Submitted in lieu of Form 3160-5  
**UNITED STATES  
DEPARTMENT OF THE INTERIOR  
BUREAU OF LAND MANAGEMENT**

Sundry Notices and Reports on Wells

1. Type of Well <b>GAS</b>	5. Lease Number <b>SF-078996</b>
2. Name of Operator <b>ConocoPhillips Company</b>	6. If Indian, All. or Tribe Name
3. Address & Phone No. of Operator <b>PO Box 4289, Farmington, NM 87499 (505) 326-9700</b>	7. Unit Agreement Name <b>San Juan 32-7 Unit</b>
4. Location of Well, Footage, Sec., T, R, M <b>Unit K (NESW) 2525' FSL &amp; 2000' FWL, Sec. 4, T31N, R7W, NMPM-Surface Unit E (SWNW) 725' FNL &amp; 1150' FWL, Sec. 4, T31N, R7W- Bottomhole</b>	8. Well Name & Number <b>19M</b>
	9. API Well No. <b>30-045-34599</b>
	10. Field and Pool <b>Blanco MV/Basin DK</b>
	<b>San Juan Co., NM</b>

WELL LOCATION AND ACREAGE DEDICATION PLAT

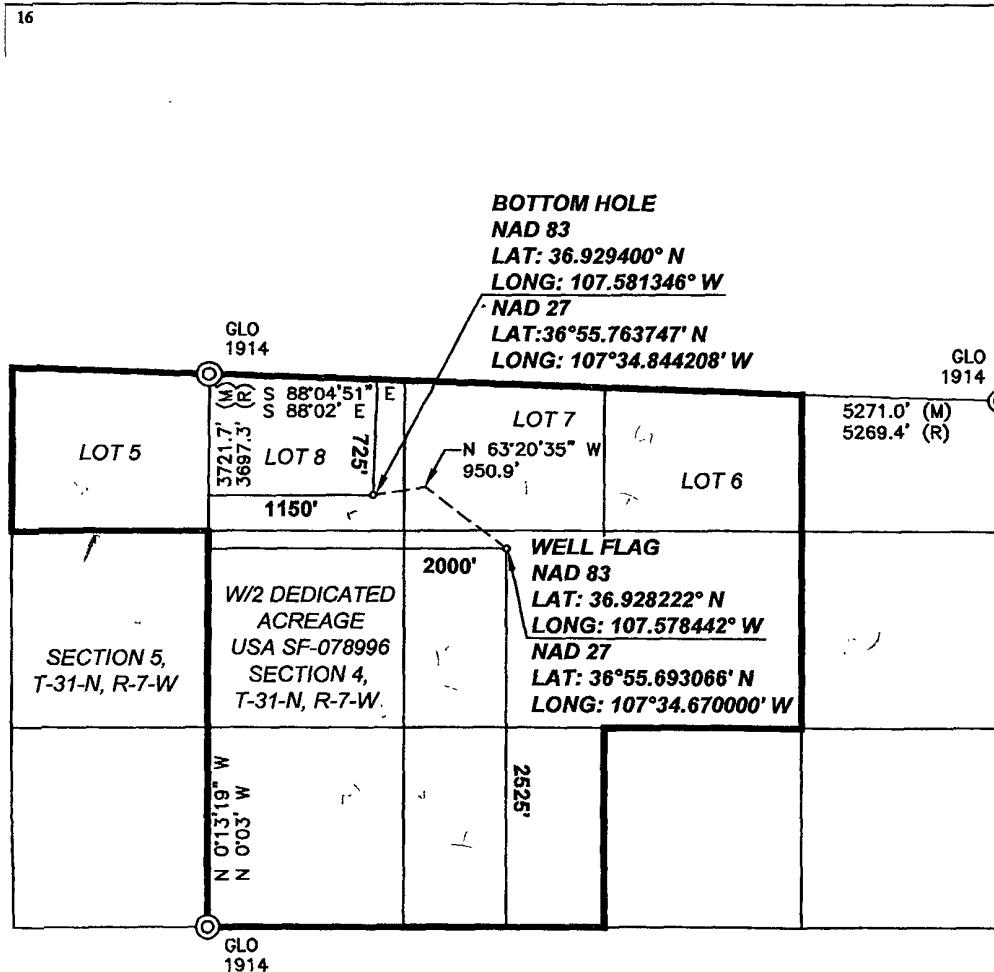
ConocoPhillips wishes to directionally drill the subject location. The original APD was approved 11/18/08 with the location of the well being Unit K (NESW) 1115' FNL & 2033' FWL, Sec. 4, T31N, R7W, which was mistakenly measured from the North instead of the South. The pad was rotated 180 degrees due to an access issue and the Bottomhole was added. The new location is **Unit K (NESW) 2525' FSL & 2000' FWL and the Bottomhole is Unit E (SWNW) 725' FNL & 1150' FWL.**  
The new plat, cut & fill, pad diagram, project proposal and directional drill plan is attached.

UL or lot no. <b>K</b>	Section <b>4</b>	Township <b>31-N</b>	Range <b>7-W</b>	Lot Idn	Feet from the <b>2525</b>	North/South line <b>SOUTH</b>	Feet from the <b>2000</b>	East/West line <b>WEST</b>	County <b>SAN JUAN</b>
---------------------------	---------------------	-------------------------	---------------------	---------	------------------------------	----------------------------------	------------------------------	-------------------------------	---------------------------

UL or lot no. <b>E</b>	Section <b>4</b>	Township <b>31-N</b>	Range <b>7-W</b>	Lot Idn	Feet from the <b>725</b>	North/South line <b>NORTH</b>	Feet from the <b>1150</b>	East/West line <b>WEST</b>	County <b>SAN JUAN</b>
---------------------------	---------------------	-------------------------	---------------------	---------	-----------------------------	----------------------------------	------------------------------	-------------------------------	---------------------------
